Report No.: 26-2-4

Project: Proposed Improvements to the Existing Athletic Stadium
Ventura High School
2 North Catalina Street
Ventura, California

Subject: Addendum Report

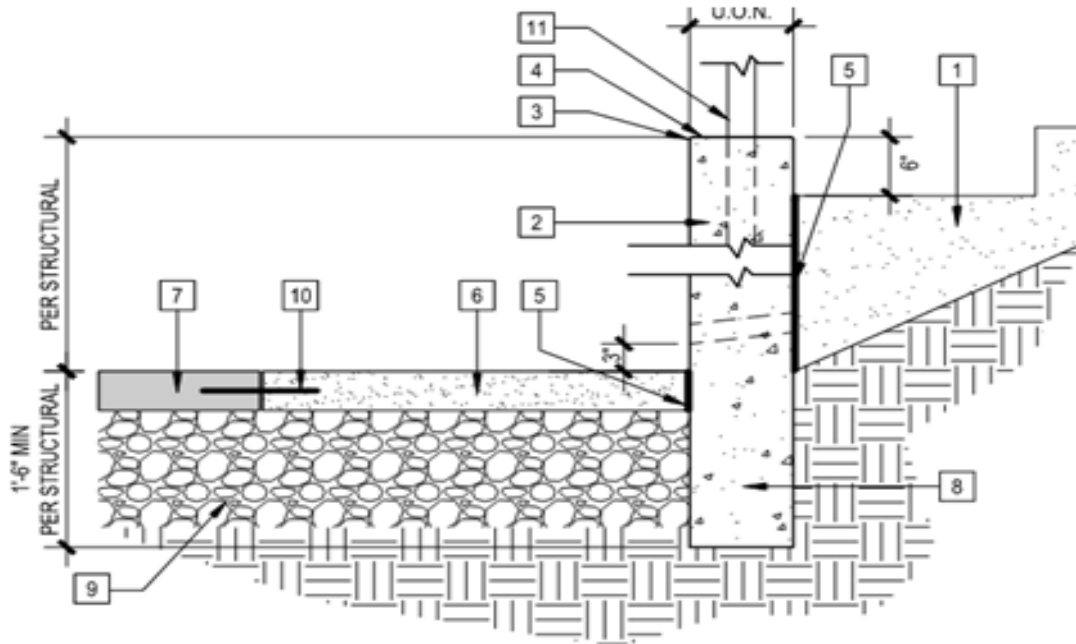
For the bleachers on the north side of the stadium, ADA seating will be provided. The ADA seating will require a small retaining wall to be constructed as shown below in the areas designated for ADA seating.

The lateral earth pressure to be resisted by the short retaining wall should be increased to allow for surcharge loads. A surcharge pressure should be added to the lateral earth pressure for surcharges within a distance at least equal to the shoring height. We understand that the project structural engineer has assigned a uniform surcharge pressure of 100 psf to account for the existing bleachers bearing directly on the ground surface.

We recommend that the continuous footing shown in the figure below should extend at least 12 inches into the firm, native soils.
